The Commission has issued the enclosed Amendment No. 8, Technical Specification Change No. 18 for License No. DPR-38; Amendment No. 8, Technical Specification Change No. 13 for License No. DPR-47; and Amendment No. 5, Technical Specification Change No. 5 for License No. DPR-55, for the Oconee Nuclear Station, Units 1, 2, and 3. These amendments are in response to your request dated May 9, 1975.

AMENDMENT TO FACILITY OPERATING LICENSE

ATTACHMENT TO LICENSE AMENDMENTS

SAFETY EVALUATION BY THE OFFICE OF NUCLEAR REACTOR REGULATION

UNIT 2
OCONEE NUCLEAR STATION
Figure 3.5.2-1B1

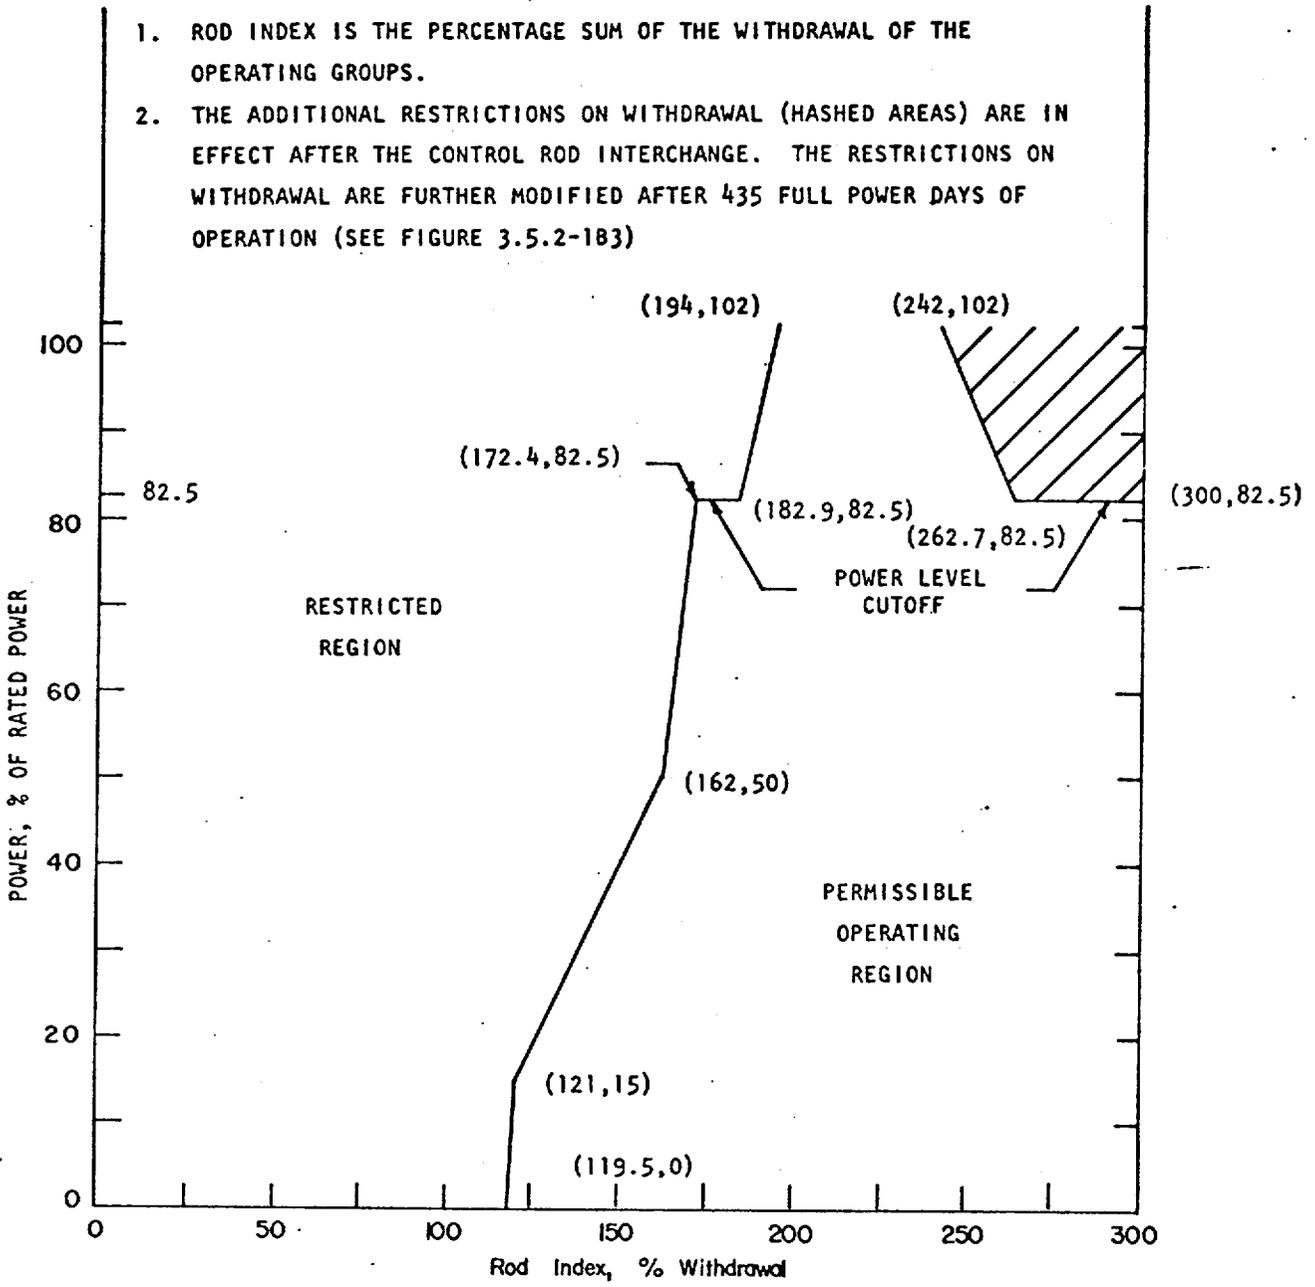
2. RESTRICTIONS ON WITHDRAWAL (HASHED AREAS) ARE MODIFIED AFTER THE CONTROL ROD INTERCHANGE (SEE FIGURE 3.5.2-1B2)

CONTROL ROD GROUP WITHDRAWAL LIMITS
FOR 4 PUMP OPERATION UNIT 2

- b. Operating rod group overlap shall be $25\% \pm 5\%$ between two sequential groups, except for physics tests.
- c. Except for physics tests or exercising control rods, the control rod withdrawal limits* are specified on Figures 3.5.2-1A1 (Unit 1), 3.5.2-1B1, 3.5.2-1B2 and 3.5.2-1B3 (Unit 2), and 3.5.2-1C1, 3.5.2-1C2, and 3.5.2-1C3 (Unit 3) for four pump operation and on Figures 3.5.2-2A (Unit 1), 3.5.2-2B (Unit 2), and 3.5.2-2C (Unit 3) for three or two pump operation. If the control rod position limits are exceeded, corrective measures shall be taken immediately to achieve an acceptable control rod position. Acceptable control rod positions shall then be attained within two hours.

UNIT 2
 OCONEE NUCLEAR STATION
 Figure 3.5.2-1B2

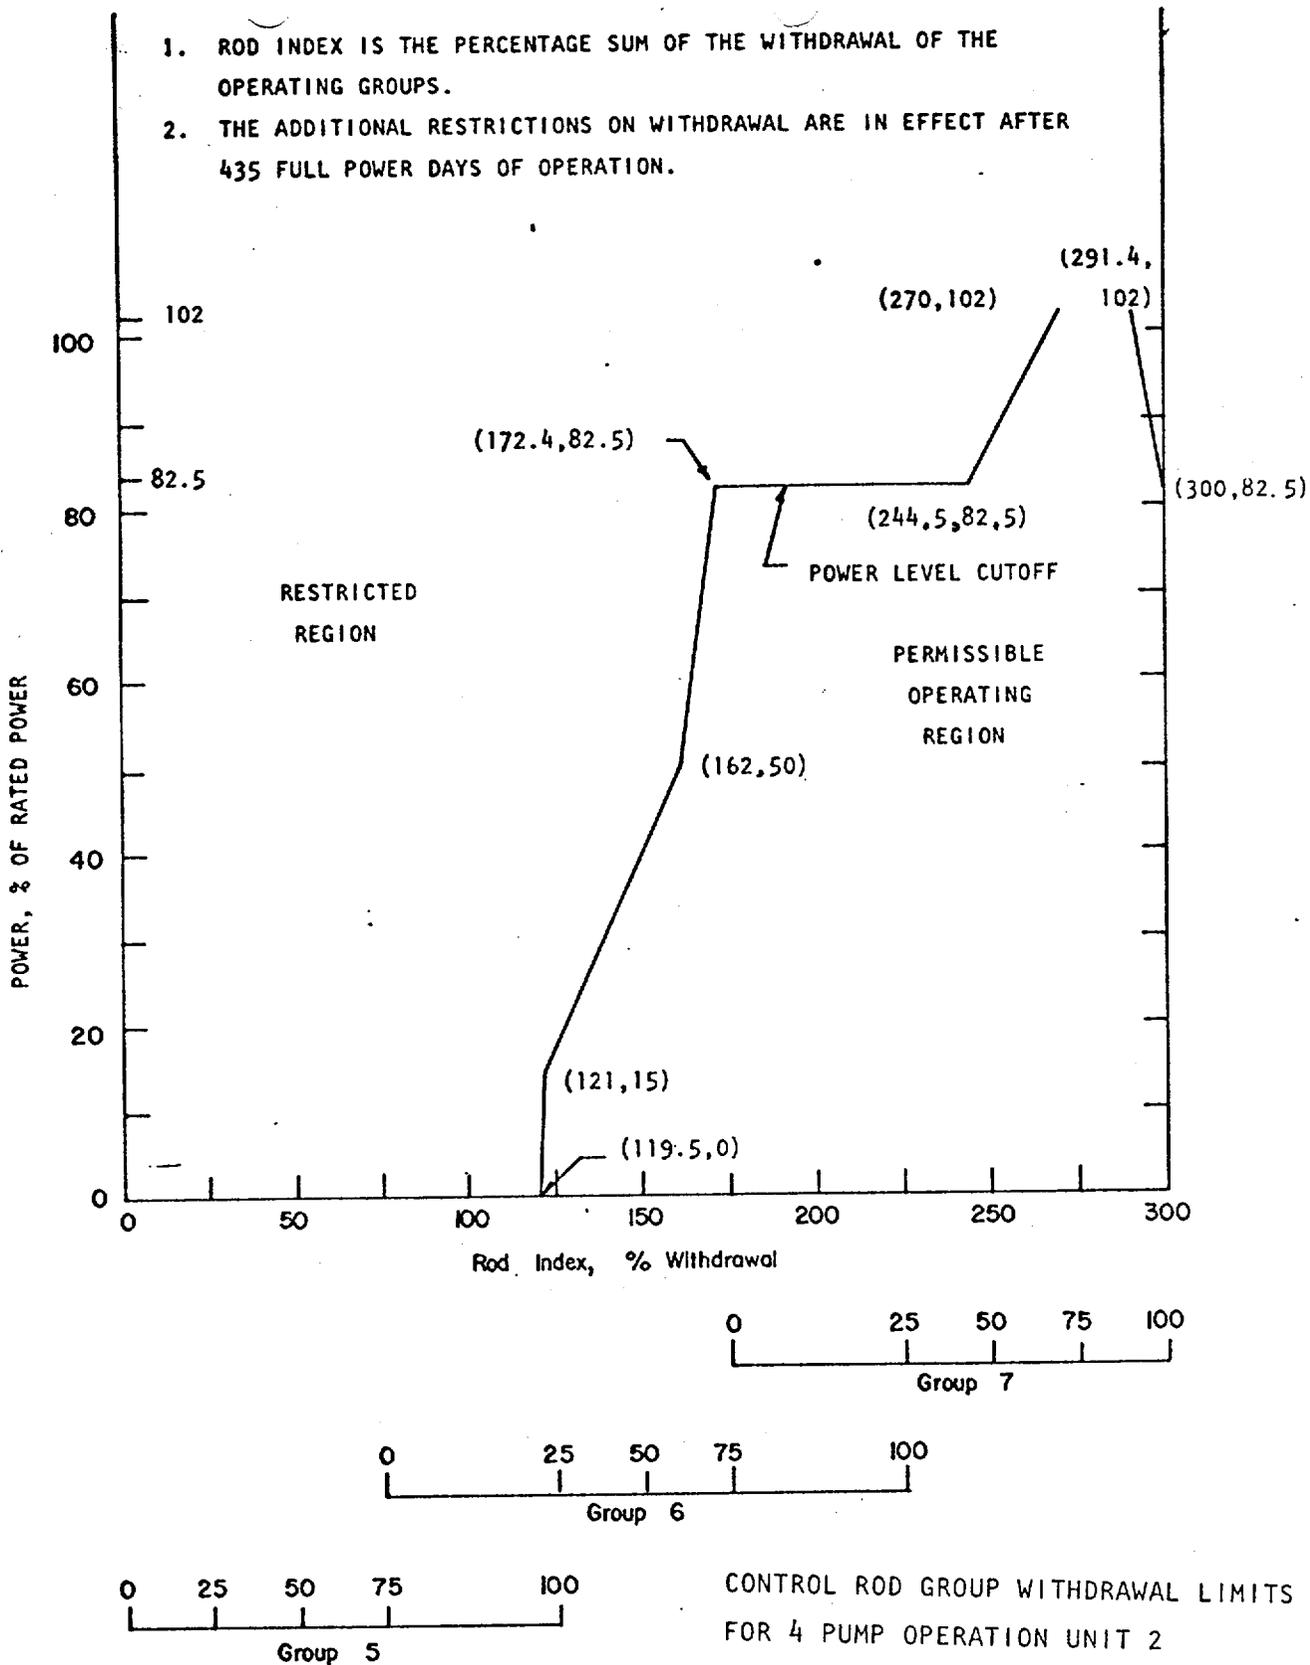
1. ROD INDEX IS THE PERCENTAGE SUM OF THE WITHDRAWAL OF THE OPERATING GROUPS.
2. THE ADDITIONAL RESTRICTIONS ON WITHDRAWAL (HASHED AREAS) ARE IN EFFECT AFTER THE CONTROL ROD INTERCHANGE. THE RESTRICTIONS ON WITHDRAWAL ARE FURTHER MODIFIED AFTER 435 FULL POWER DAYS OF OPERATION (SEE FIGURE 3.5.2-1B3)

CONTROL ROD GROUP WITHDRAWAL LIMITS FOR 4 PUMP OPERATION UNIT 2

UNIT 2
 OCONEE NUCLEAR STATION
 Figure 3.5.2-1B3

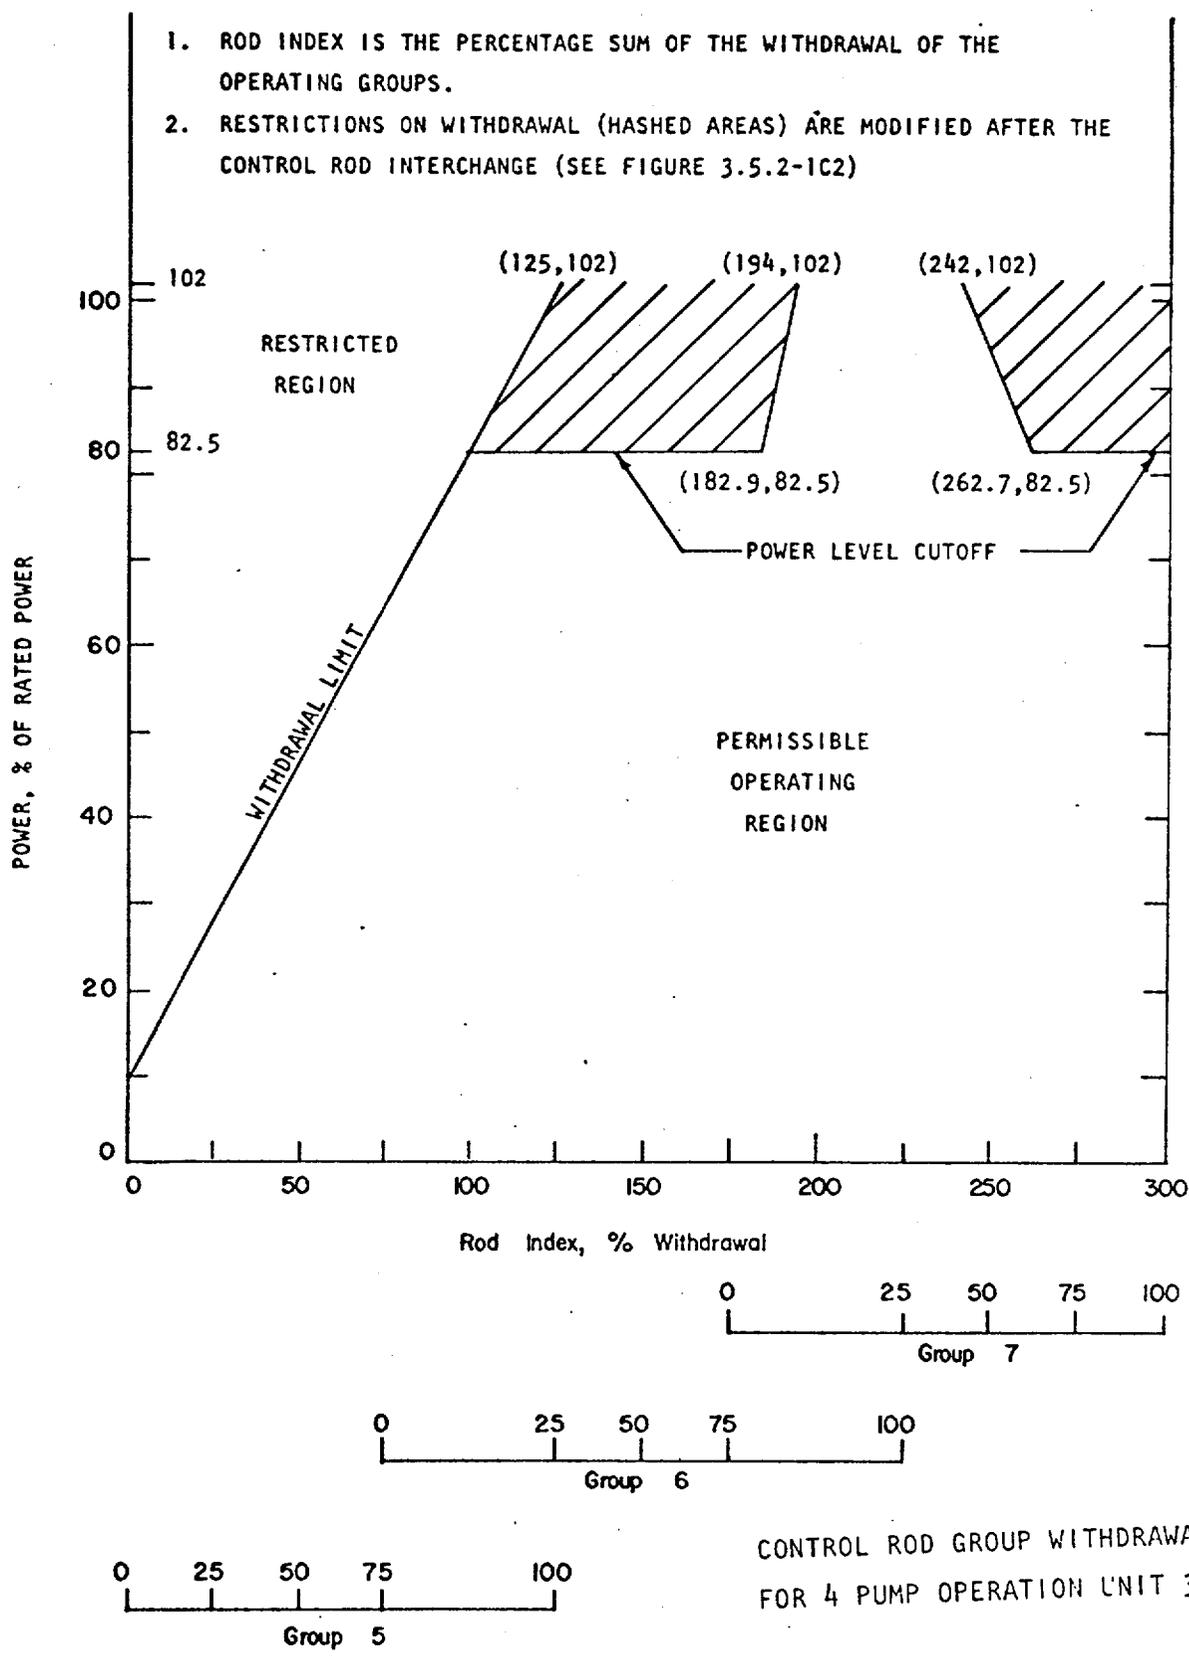
1. ROD INDEX IS THE PERCENTAGE SUM OF THE WITHDRAWAL OF THE OPERATING GROUPS.
2. THE ADDITIONAL RESTRICTIONS ON WITHDRAWAL ARE IN EFFECT AFTER 435 FULL POWER DAYS OF OPERATION.

CONTROL ROD GROUP WITHDRAWAL LIMITS FOR 4 PUMP OPERATION UNIT 2

UNIT 3
 OCONEE NUCLEAR STATION
 Figure 3.5.2-1C1

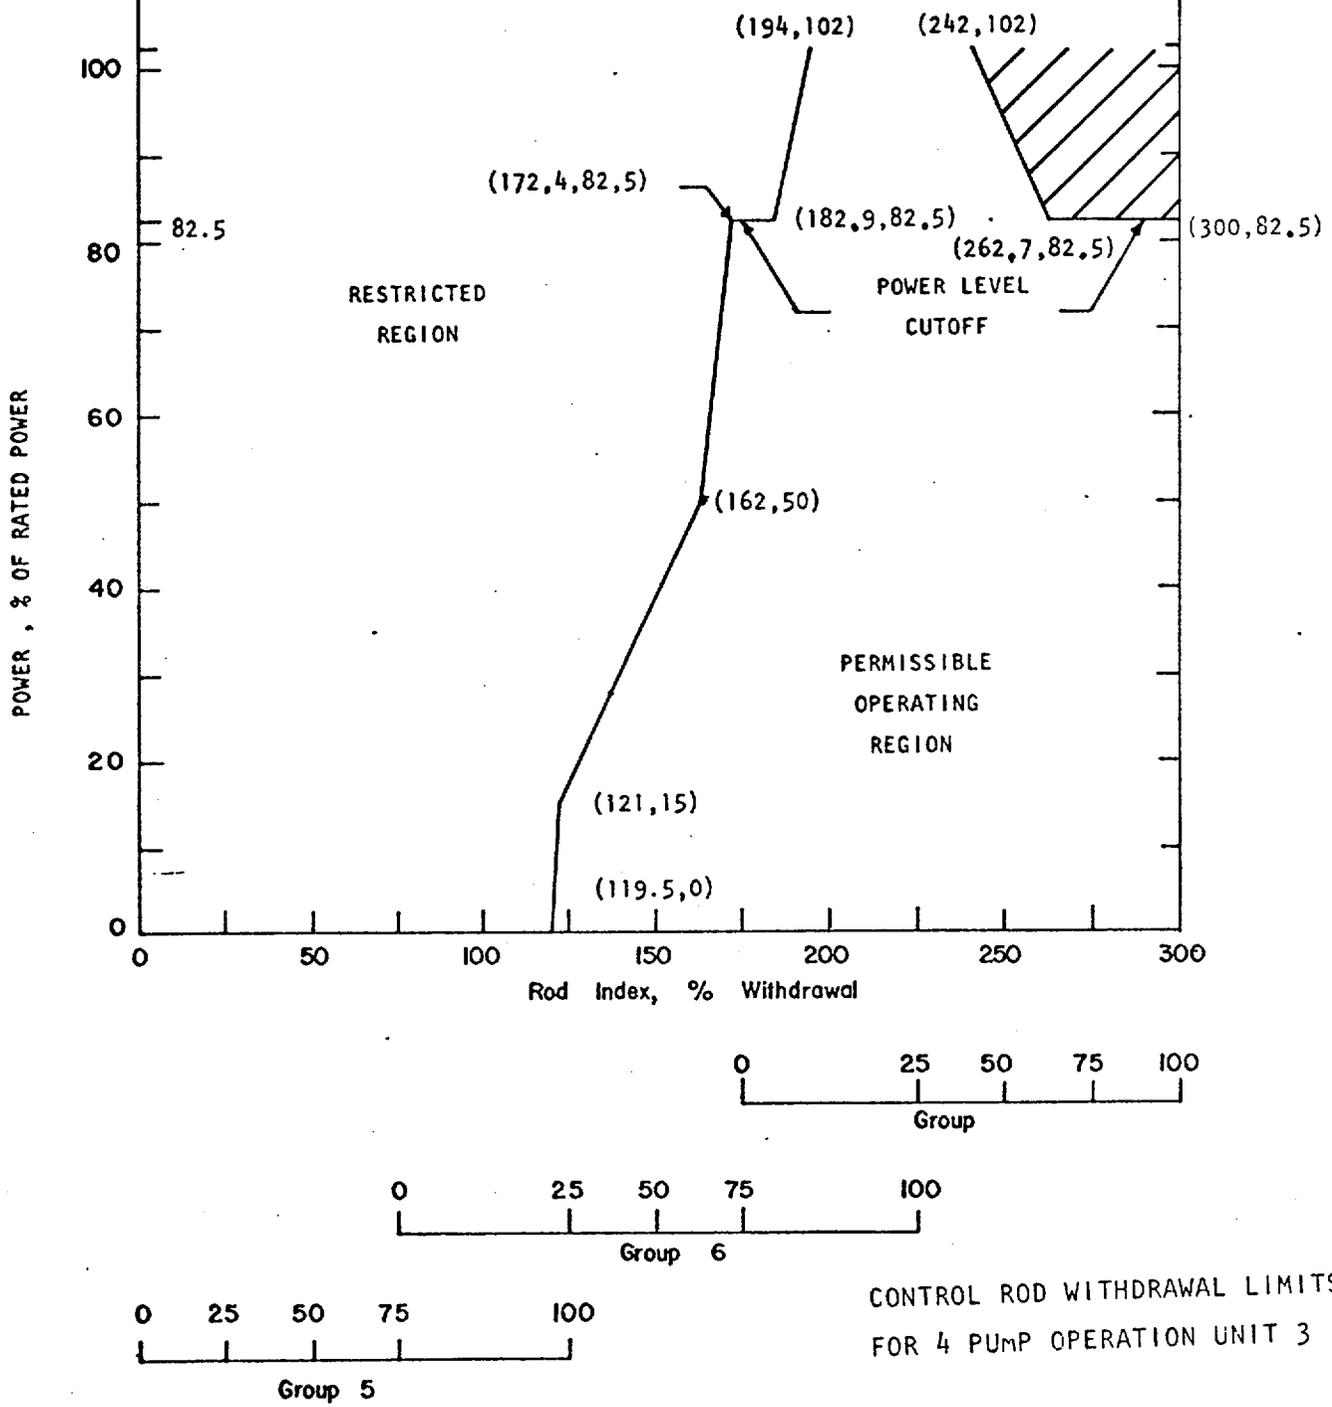
1. ROD INDEX IS THE PERCENTAGE SUM OF THE WITHDRAWAL OF THE OPERATING GROUPS.
2. RESTRICTIONS ON WITHDRAWAL (HASHED AREAS) ARE MODIFIED AFTER THE CONTROL ROD INTERCHANGE (SEE FIGURE 3.5.2-1C2)

CONTROL ROD GROUP WITHDRAWAL LIMITS FOR 4 PUMP OPERATION UNIT 3

UNIT 3
 OCONEE NUCLEAR STATION
 Figure 3.5.2-1C2

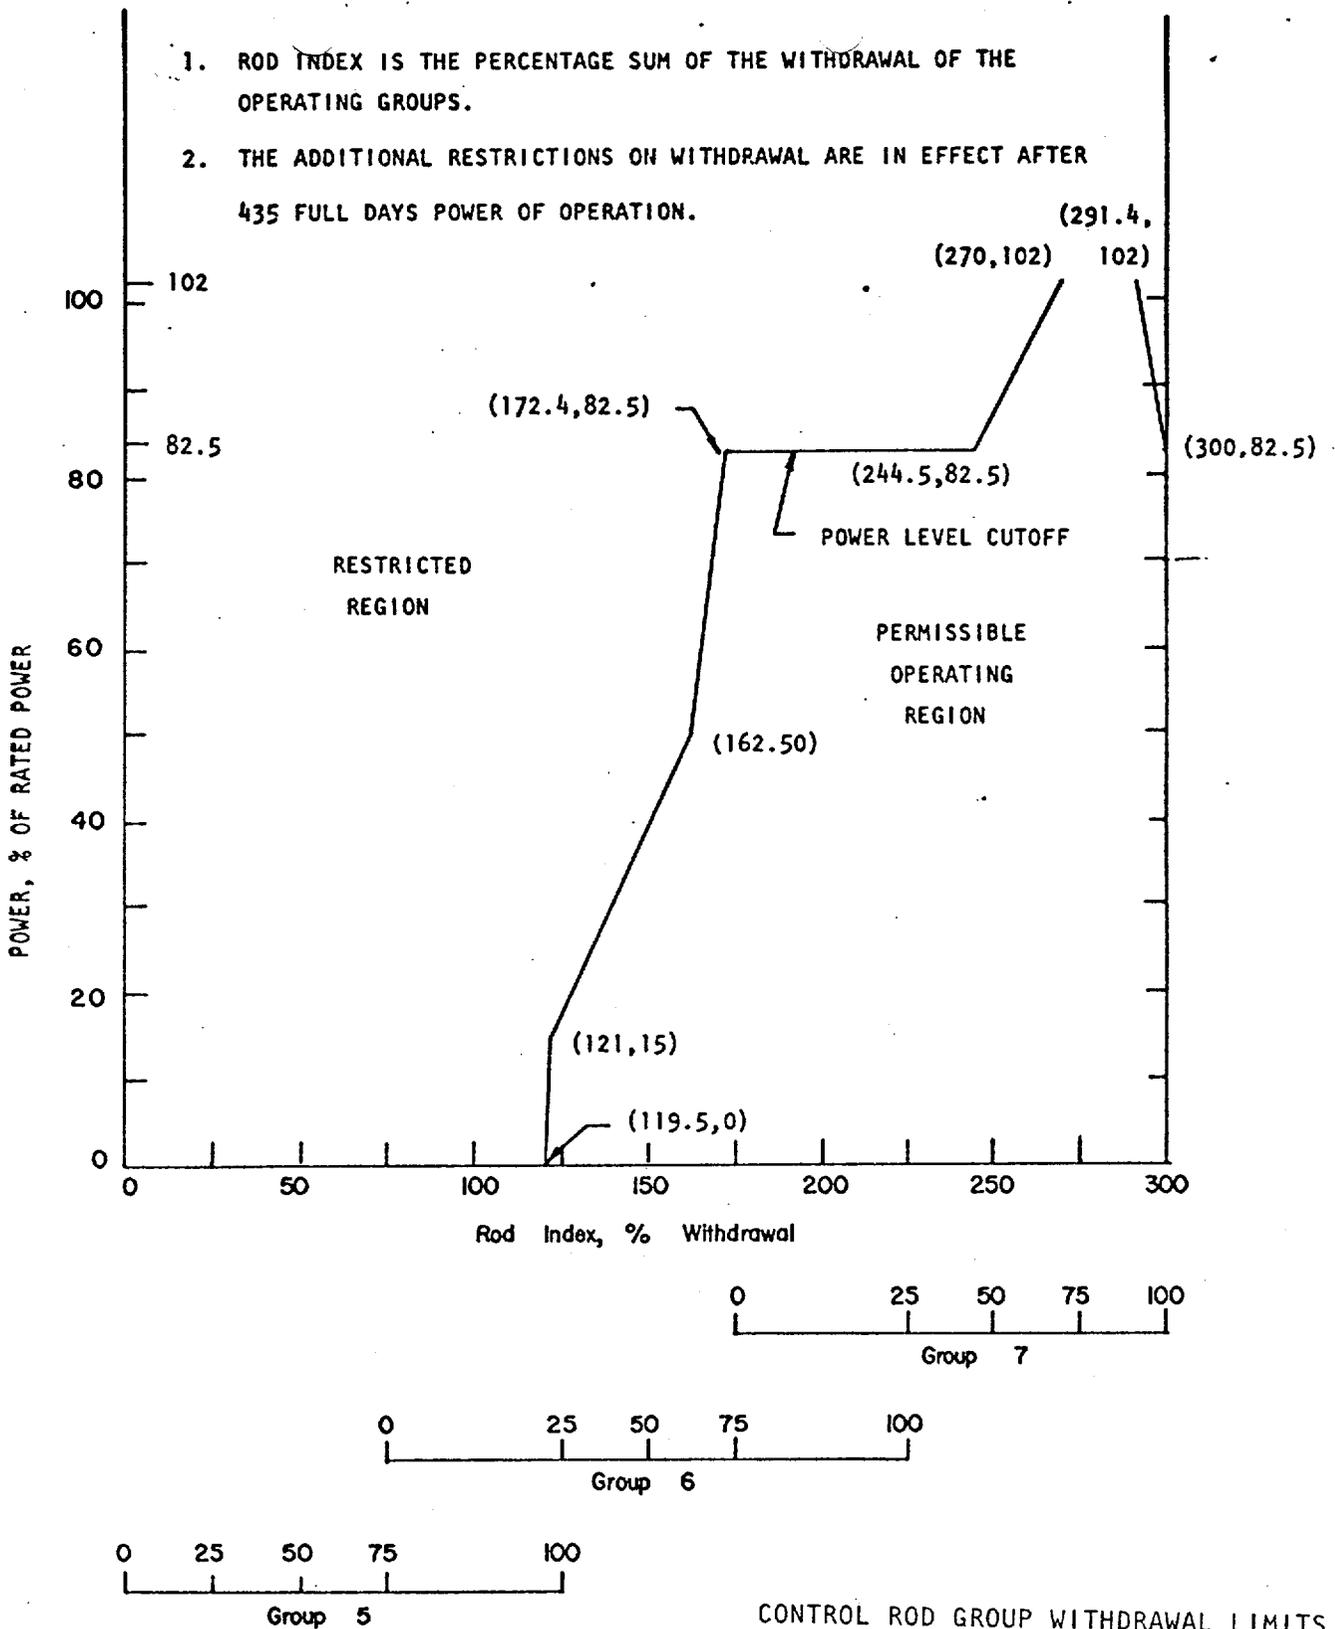
1. ROD INDEX IS THE PERCENTAGE SUM OF THE WITHDRAWAL OF THE OPERATING GROUPS.
2. THE ADDITIONAL RESTRICTIONS ON WITHDRAWAL (HASHED AREAS) ARE IN EFFECT AFTER THE CONTROL ROD INTERCHANGE. THE RESTRICTIONS ON WITHDRAWAL ARE FURTHER MODIFIED AFTER 435 FULL POWER DAYS OF OPERATION (SEE FIGURE 3.5.2-1C3)

CONTROL ROD WITHDRAWAL LIMITS FOR 4 PUMP OPERATION UNIT 3
